To: T10 Technical Committee  
From: Jim Hatfield, Seagate (James.C.Hatfield@seagate.com),  
Rob Elliott, HP (elliott@hp.com)  
Date: June 12, 2007  
Subject: SAT-2 Translation of Large Physical Blocks

ATA8-ACS defines how an ATA device reports its geometry of logical and physical sectors. SBC-3 defines how a SCSI device server reports similar information. This proposal describes how to map these geometry parameters between ATA and SCSI.

**Figure 1- LOWEST ALIGNED LOGICAL BLOCK ADDRESS field examples**

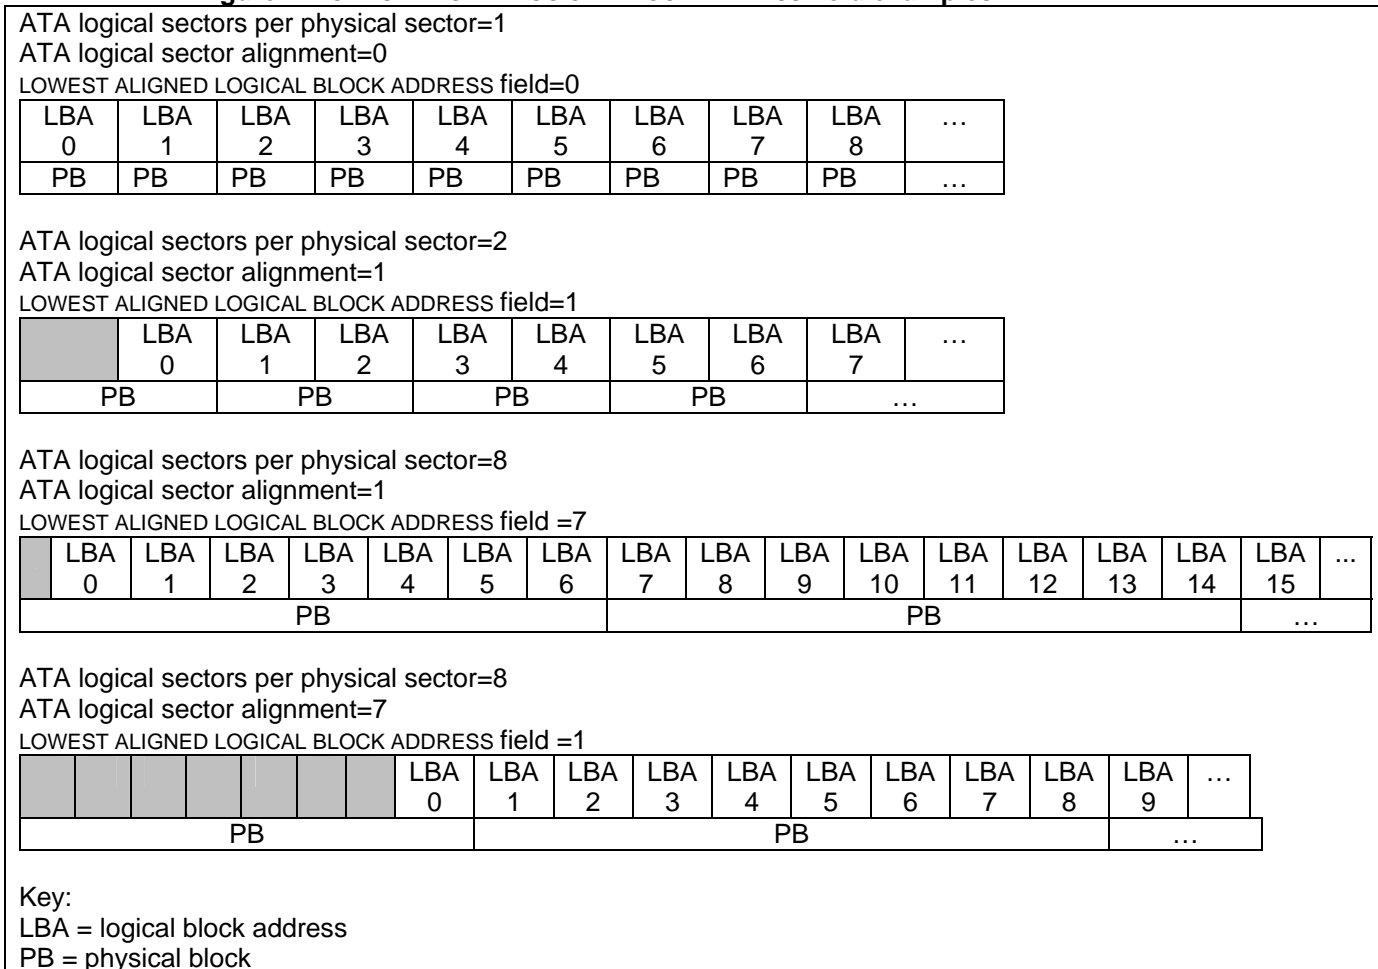
[Figure 1 shows examples of LOWEST ALIGNED LOGICAL BLOCK ADDRESS field values for various values of ATA logical sector alignment and ATA logical sectors per physical sector.](#)

[Editor's note: Figure must be converted into Visio. Get a reformatted version of this figure from Ralph Weber\]](#)
